# REGIONAL REVIEW NOTICE

ARC REVIEW CODE: R1610101

**Name of Proposal:** Palmetto Distribution Center

**PALMETTO DISTRIBUTION CENTER DRI**  
**City of Palmetto**  
**Natural Resources Division Review Comments**  
**September 7, 2016**

DRI PLAN  
PALMETTO DISTRIBUTION CENTER  
PALMETTO, GA  
MAY 26, 2016

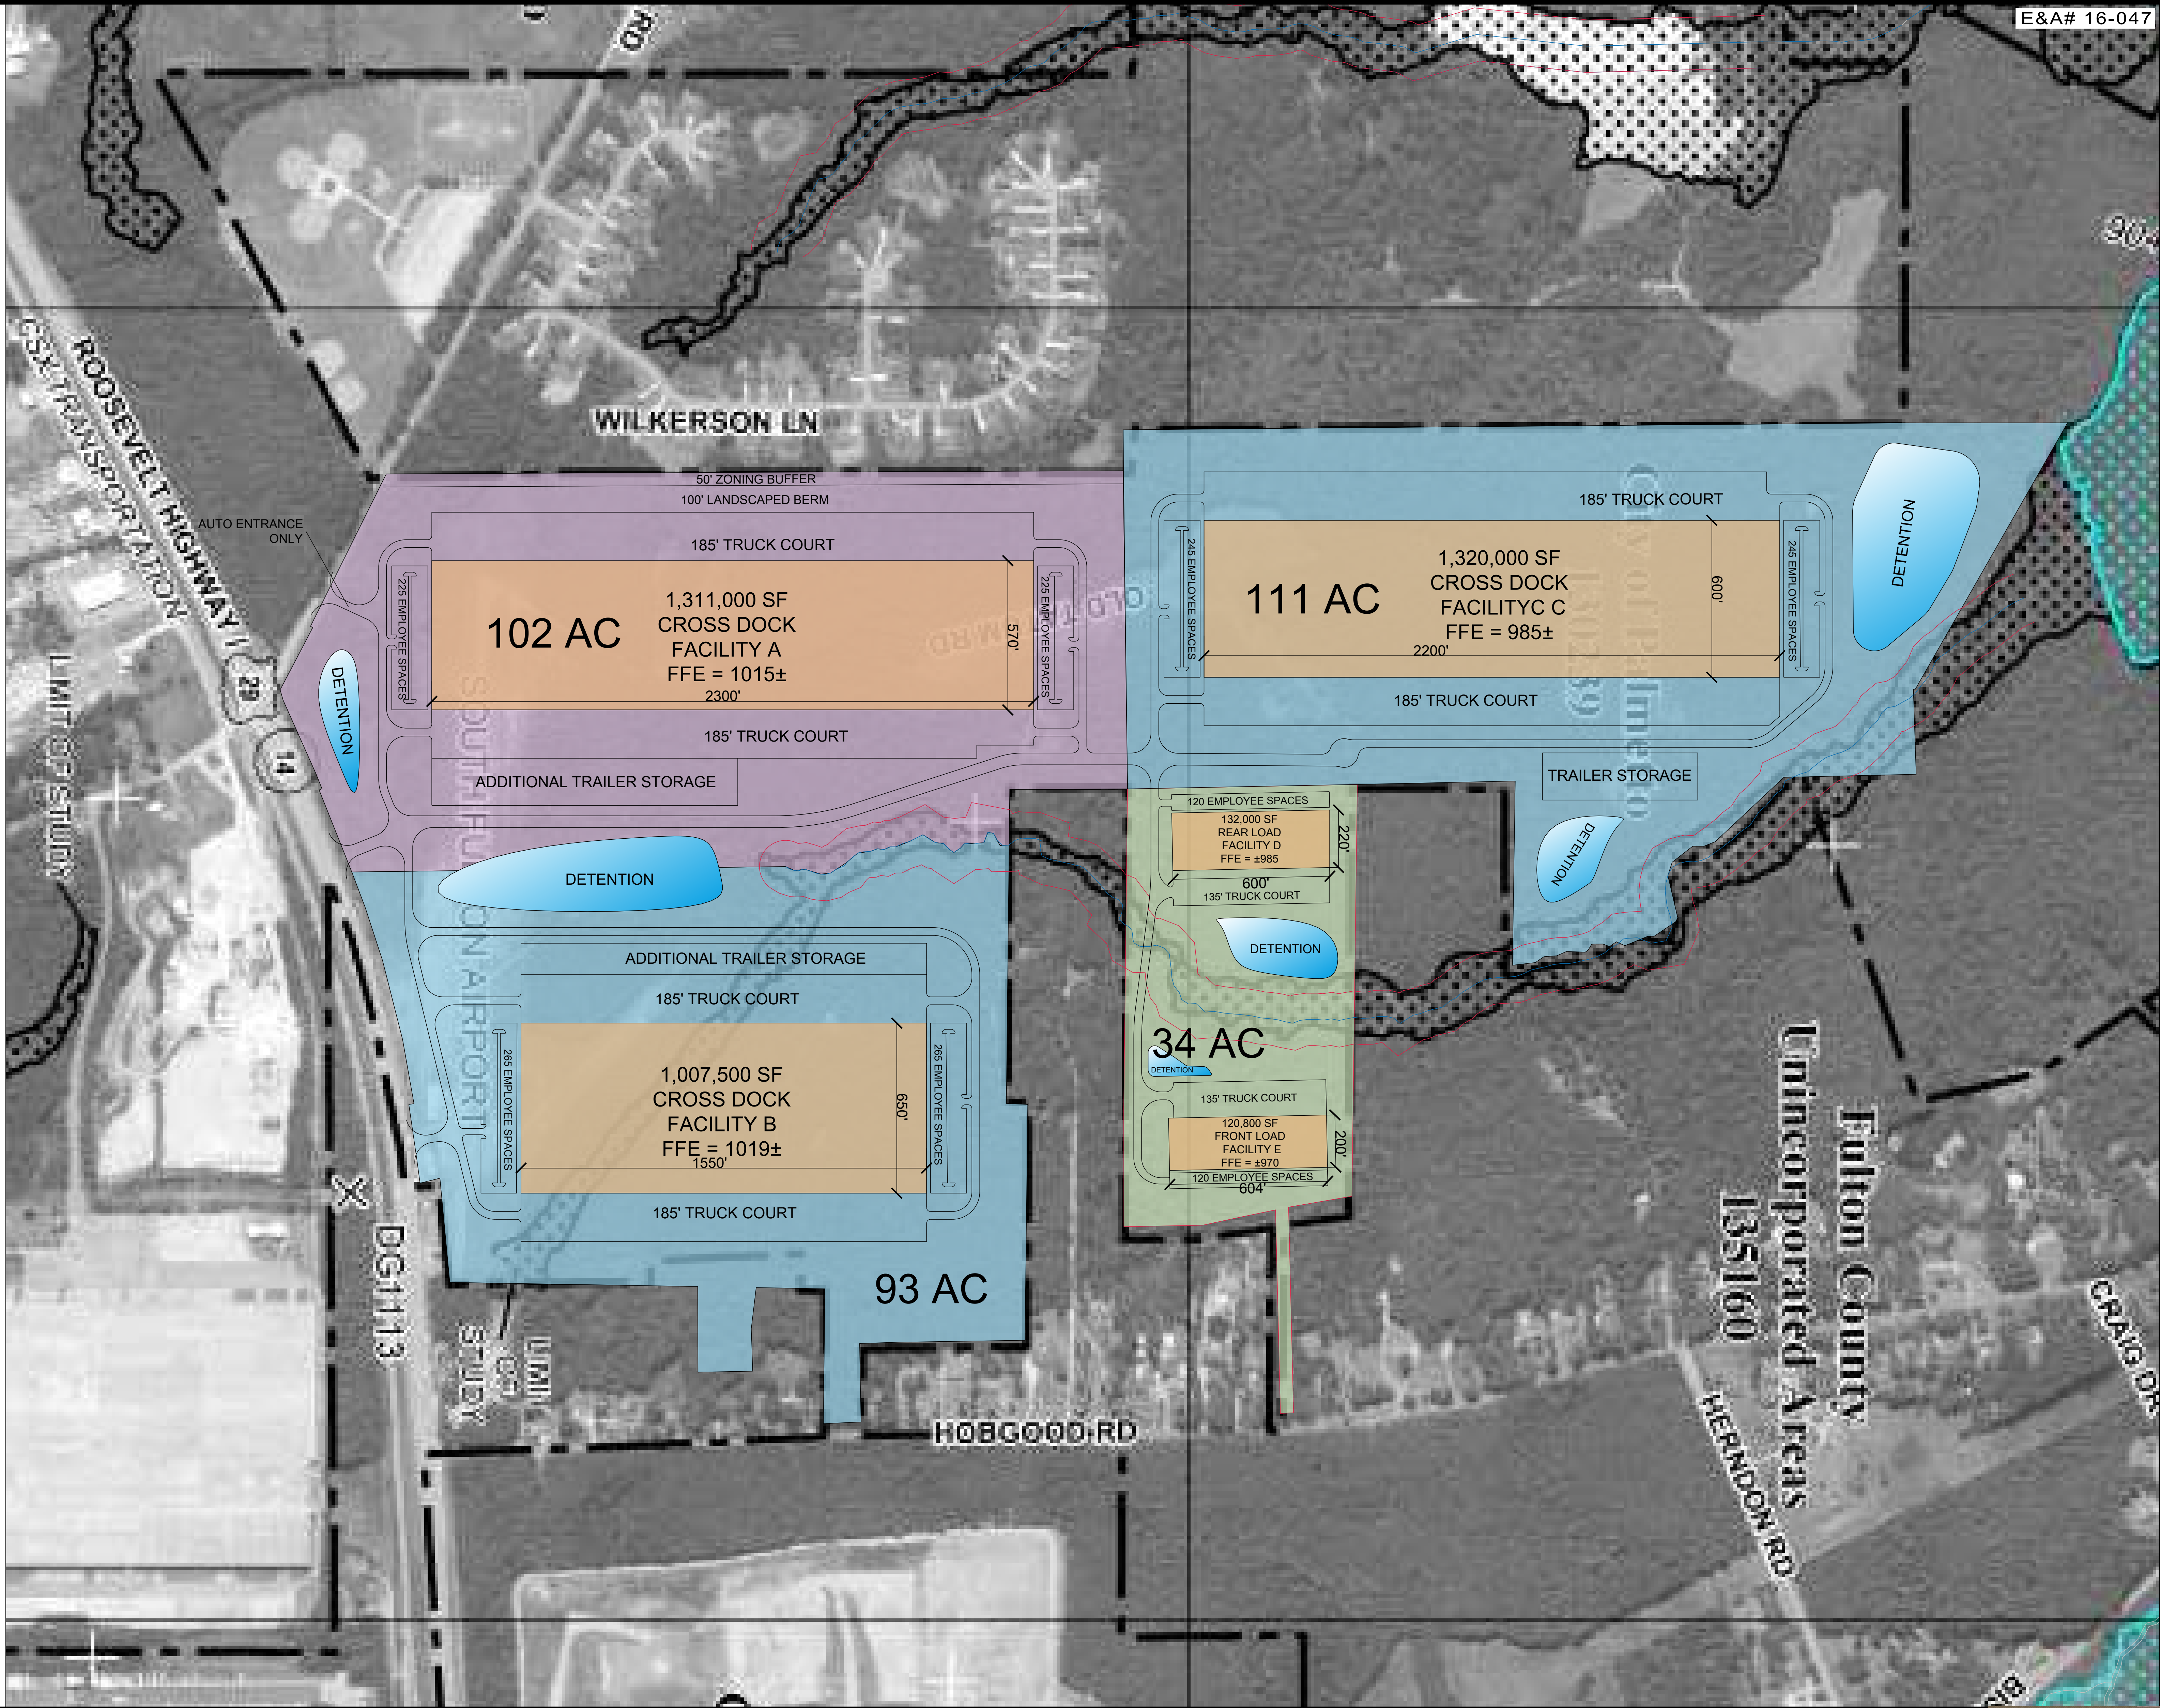
There are no existing bicycle and pedestrian facilities along SR 29 adjacent to the site. The site plan does not depict proposed sidewalks or crosswalks for internal or external access to the site. The traffic study does discuss making considerations for sidewalk and pedestrian access from nearby bus stops to the site.

The traffic study shows existing conditions along the route adjacent to the site includes a higher percentage of passenger vehicles than truck traffic. The proposed development is estimated to introduce an increase in the percentage of traffic in the project area, with 40 % being passenger vehicles and 60% being truck traffic. The site plan does depict a designated entrance for vehicular

access to the site from Wilkerson Road as well as designated vehicular parking throughout the site. The information does not denote any separation between vehicular and truck traffic via lanes internal to the site.

The traffic study discusses proposed improvements that include additional turn lanes and a traffic signal at one of the proposed entrances. The site plan does not depict the proposed improvements. It should also be noted that in the summary and conclusion (pages, 1 and 33 ) there is discussion about a proposed traffic signal at one of the access points, however, on page 7, all access points to the site are characterized as unsignalized. To determine feasibility of the transportation improvements proposed, a conceptual design plan of the roadway and site visit are necessary.

With the proposed level of increase in truck traffic over vehicular traffic on SR 29 which will impact current LOS levels, ARC recommends careful consideration be given to both transportation system . The site plan does not depict interconnectivity between future compatible developments. ARC encourages practices that promote interconnectivity between compatible developments through provisions for both pedestrian and vehicular access means.
